## Executive Director's Recommendation

Commission Meeting: March 7, 2019

<b>PROJECT</b> <b>Washington DC VA Medical Center Oncology and Cancer Center - Renovations and Addition</b> 50 Irving Street, NW Washington, DC	<b>NCPC FILE NUMBER</b> 8038
<b>SUBMITTED BY</b> US Department of Veterans Affairs Veterans Health Administration	<b>NCPC MAP FILE NUMBER</b> 12.20(38.00)44866
<b>REVIEW AUTHORITY</b> Federal Projects in the District per 40 U.S.C. § 8722(b)(1) and (d)	<b>APPLICANT'S REQUEST</b> Approval of comments on concept plans
	<b>PROPOSED ACTION</b> Approve comments on concept plans as requested
	<b>ACTION ITEM TYPE</b> Consent Calendar

# Proposed Site Plan

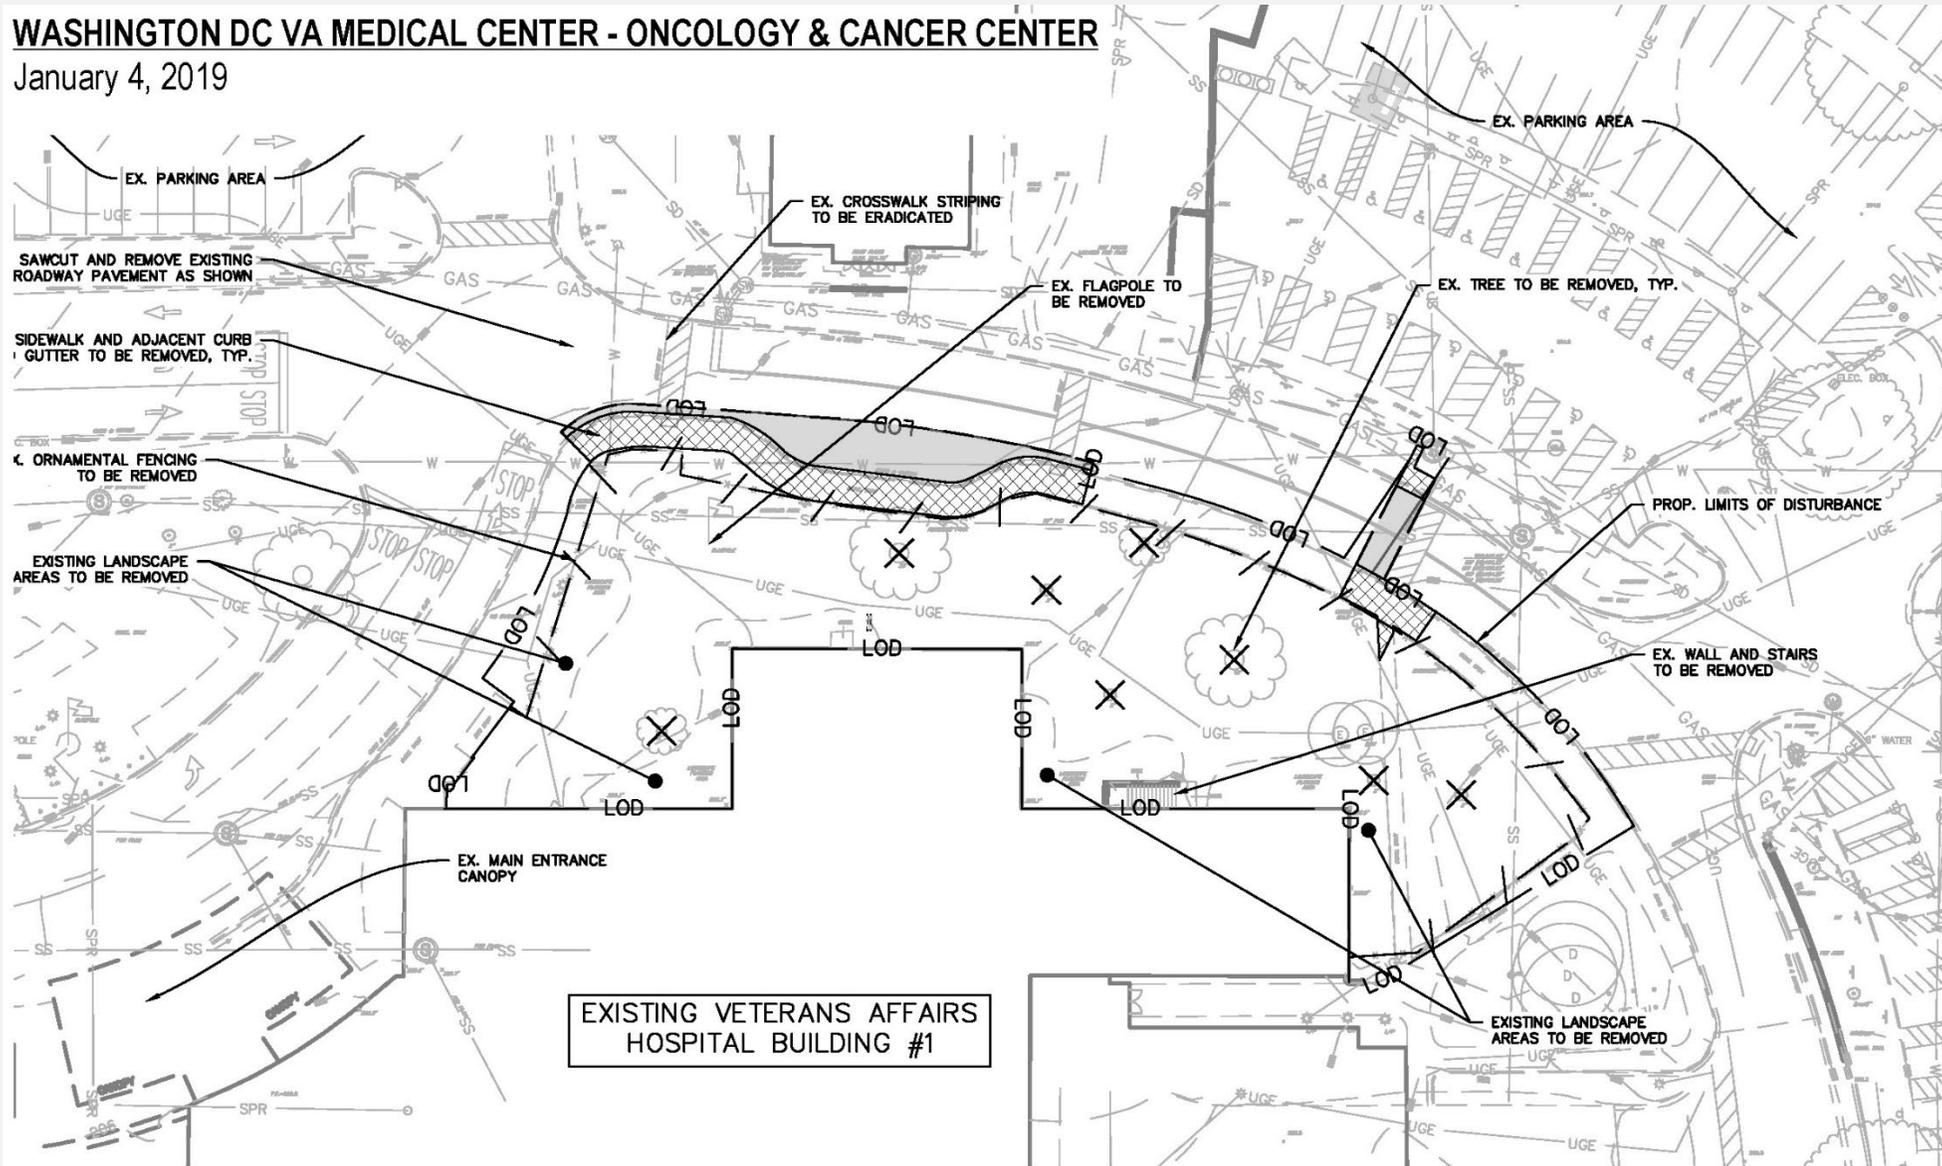
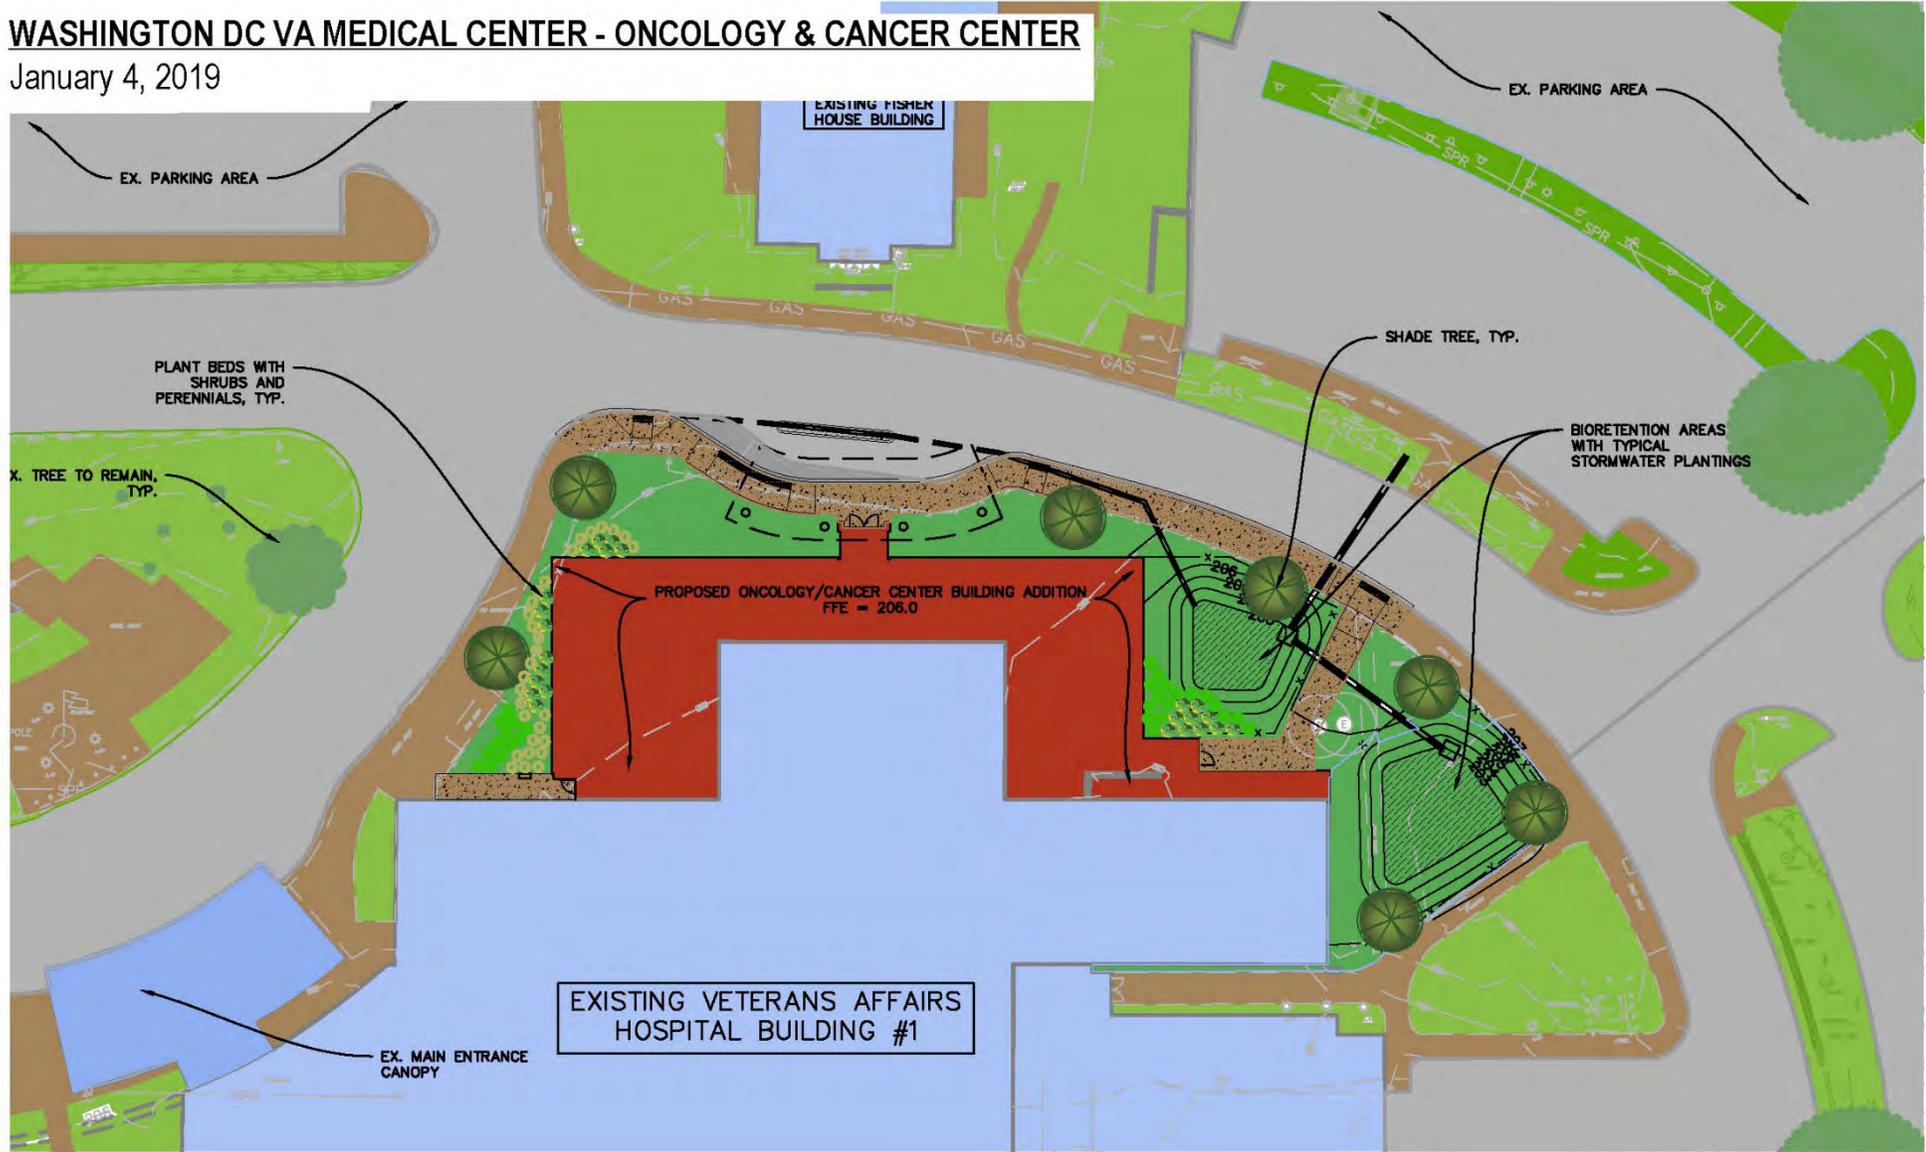
**Notes** that the project proposes the removal of eight trees, including two large, mature trees, and six smaller trees across the project area, and that seven new trees would be planted.

**Requires** that the applicant prevent a net loss of tree canopy for the project in accordance with the policies related to Tree Canopy and Vegetation in the Comprehensive Plan for the National Capital, which generally state that the caliper of trees lost as a result of a project must be replaced in-kind. This could be accomplished through the planting of additional trees, the planting of larger trees, or a combination of both.

**Requests** that the applicant considers low-impact development features or green infrastructure to retain and treat stormwater, such as bioswales or rain gardens with native stormwater plantings and a vegetated rooftop on the proposed building addition.

While staff supports the project overall, the proposed landscape modifications appear to have the greatest impact, particularly related to the removal of on-site trees. The landscape plan includes the removal of eight trees to accommodate the building addition, including two large, mature trees, and six smaller trees across the project area, which they plan to replace with seven new trees. Because of the need for a dedicated drop off at the OCC, it would be difficult to reorganize the project plan to avoid these impacts. There are several areas of potential transportation conflict in close proximity that limit alternative options, including a loading zone and the main building drop off. Given these constraints, staff supports the proposal, but believes it is critically important to consider impacts to the urban tree canopy. Accordingly, staff recommends that the Commission **requires that the applicant prevent a net loss of tree canopy for the project in accordance with the policies related to Tree Canopy and Vegetation in the *Comprehensive Plan for the National Capital*, which generally state that the caliper of trees lost as a result of a project must be replaced in-kind. This could be accomplished through the planting of additional trees, the planting of larger trees, or a combination of both.**

Other notable landscape considerations include the plan for stormwater management. The DC VAMC has indicated that they will meet both federal and local stormwater requirements, in accordance with stormwater management policies articulated in the Comprehensive Plan, which they plan to accomplish with two bioretention areas. They have further noted that there is an option to construct a green roof on the proposed addition. Staff generally supports the proposed approach to stormwater management but encourages the applicant to think creatively about stormwater management strategies that have a minimal visual impact on the landscape. Accordingly, staff recommends that the Commission **requests that the applicant consider low-impact development features or green infrastructure to retain and treat stormwater, such as bioswales or rain gardens with native stormwater plantings and a vegetated rooftop on the proposed building addition.** To inform future reviews, staff further recommends that the Commission **requests a more detail regarding proposed landscape treatments and stormwater management features, including a planting plan that outlines type and variety of trees and plantings.**
